# Access Compliance Report

## Public Rights-of-Way

### (Curb Ramps)

Intersection ID: 26096	Main Street: PARK_RD	Cross Street: BLUE_HERON_DR	Location: NW
ADA ID: FF6294ED51E0	Ramp Type: Perp	Initial Pass/Fail: Fail	Overall Compliance: No
		Severity Score: 12.5

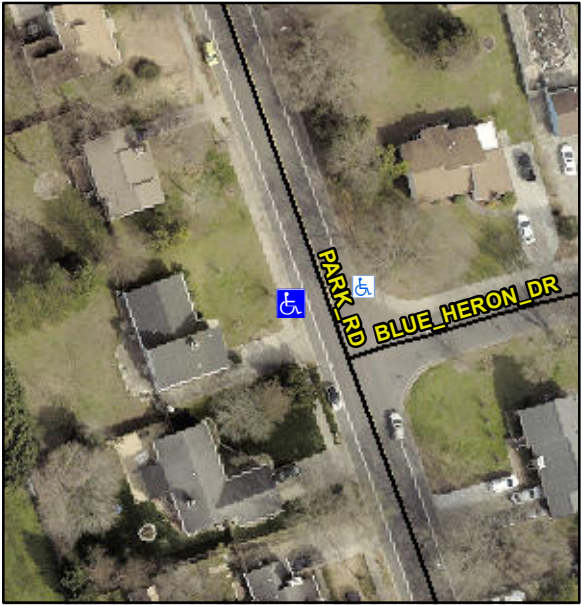
Codes/Mitigation Info/Possible Solution			Field Measurements/Component Compliance		
	Possible Solutions:		<b>Compliance</b>	<b>Description</b>	<b>Data</b>
	<b>Remove &amp; Replace Entire Ramp.</b>		<b>No</b>	Ramp Length (in)	86.0
			<b>Yes</b>	Ramp Width (in)	48.0
			<b>N/A</b>	Flare Type LT	N/A
			<b>N/A</b>	Flare Slope LT (%)	N/A
			<b>N/A</b>	Flare Traversable LT?	N/A
			<b>N/A</b>	Landing Length (in)	N/A
			<b>N/A</b>	Landing Width (in)	N/A
			<b>N/A</b>	Landing Slope (%)	N/A
			<b>N/A</b>	Landing X Slope (%)	N/A
<p>Surveyor Notes:</p> <p><b>N/A</b></p> <p>PROW/ADA:</p> <p><b>Not Found, R304.2.2</b></p>			<b>N/A</b>	Flare Type RT	N/A
			<b>N/A</b>	Flare Slope RT (%)	N/A
			<b>N/A</b>	Flare Traversable RT?	N/A
			<b>N/A</b>	DWS Provided?	N/A
			<b>N/A</b>	DWS Contrast?	N/A
			<b>N/A</b>	DWS Length (in)	N/A
			<b>N/A</b>	DWS Full Width?	N/A
			<b>N/A</b>	DWS Offset (in)	N/A
			<b>N/A</b>	Shared Landing?	N/A

<b>N/A</b>	Gutter Ponding?	N/A
			<b>N/A</b>	Gutter Lip Ht (in)	N/A
			<b>N/A</b>	Painted X Walk1?	No
				X Walk 1 Direction	To E
			<b>N/A</b>	X Walk 1 Width (in)	N/A
				X Walk 1 Slope (%)	5.2
				X Walk 1 X Slope (%)	1.9
			<b>N/A</b>	Ramp inside XWalk1?	N/A
			<b>N/A</b>	Road Slope (%)	N/A
			<b>N/A</b>	Road X Slope (%)	N/A
			<b>N/A</b>	Any Obstructions?	N/A
				Obstruction Type	
			<b>N/A</b>		
			<b>N/A</b>		
			<b>N/A</b>		
			<b>N/A</b>		
			<b>N/A</b>		
			<b>N/A</b>		
			<b>N/A</b>		
			<b>N/A</b>		
			<b>N/A</b>		
Total Cost:		\$ 1850.00			
			<b>N/A</b>		
			<b>Yes</b>	Surface Condition? (G/P)	Good
